SECTION 00 9113.01 - ADDENDUM #1

- A. Project Name: **North Central State Office Building.**
- B. Owner: **ND Office of Management & Budget.**
- C. Architect: **Ackerman-Estvold, Engineering & Management Consulting, Inc.**
- D. Architect Project Number: **R25110.**
- E. Date of Addendum: **03/04/2026.**

ELECTRICAL ADDENDUM #E1

North Central State Office Building
Minot, North Dakota
25048

4 SOUTHWEST ELEVATION
A201 1/8" = 1'-0"

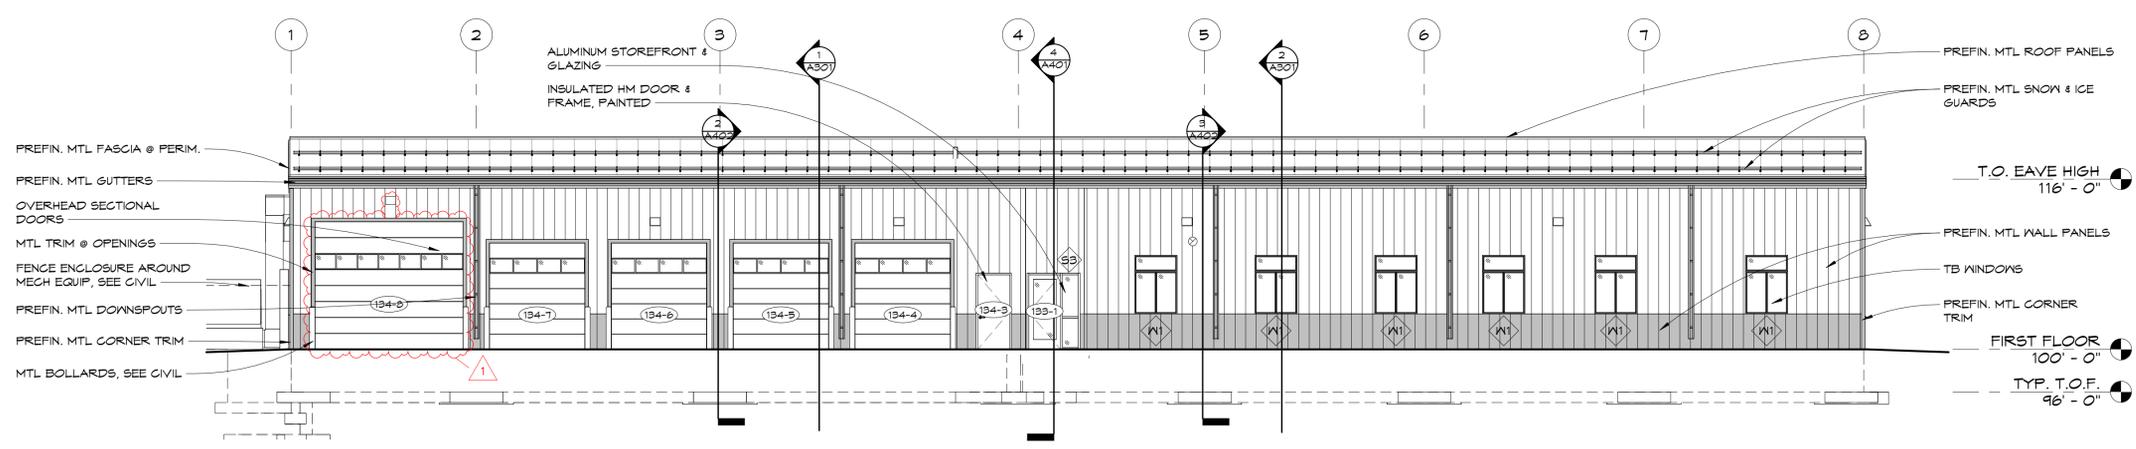
- B. Sheet A201 – Exterior Elevations (reissued).
 1. Drawing 4/A201: Revised height of door 134-8 to be 12'-0" in lieu of 10'-0".
- C. Sheet A600 - Door & Window Schedules & Types (reissued).

3 GENSET PAD DETAIL
E001 NTS

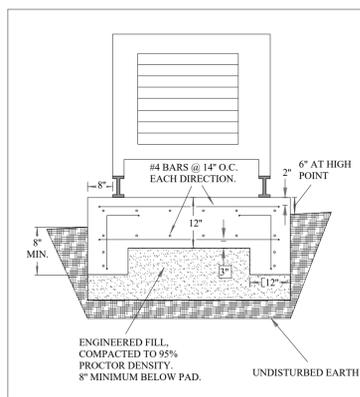
DRAWING ITEM #2. Detail 3/E001

- A. Added detail in its entirety.

1 Site Plan
E001 1/16" = 1'-0"

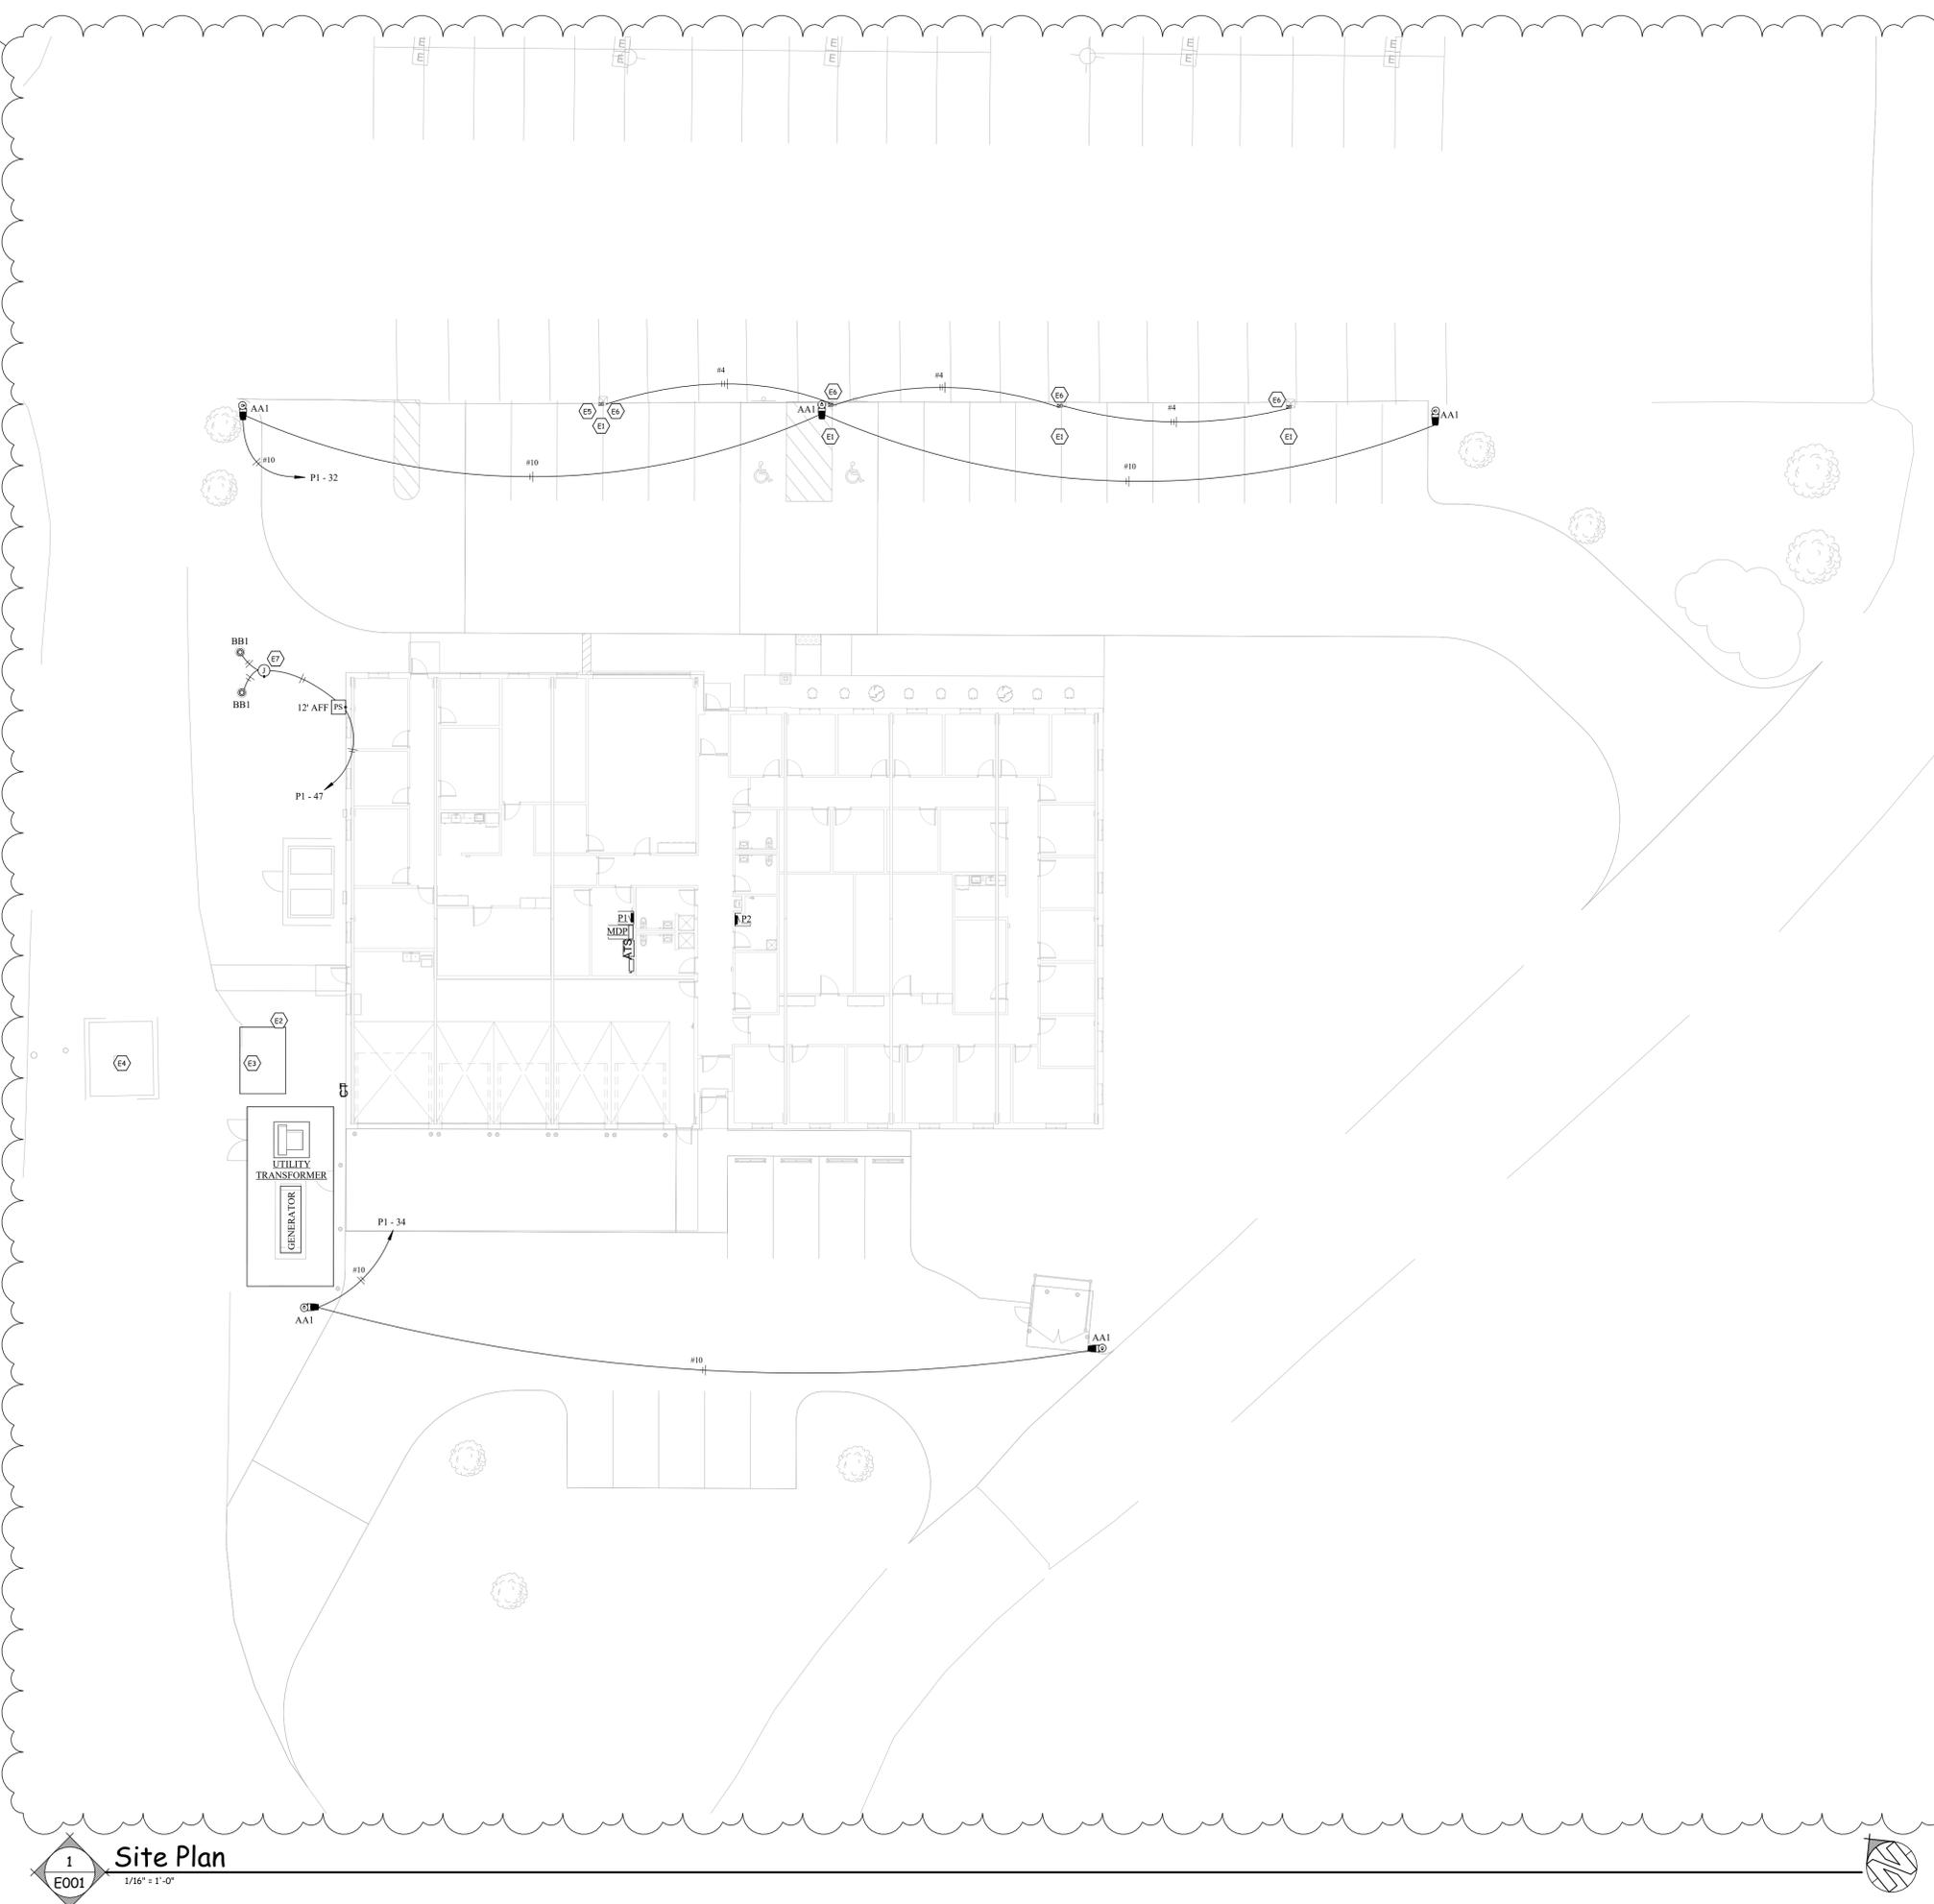
DRAWING ITEM #1. Detail 1/E001

- A. Updated the background to match the civil drawings.
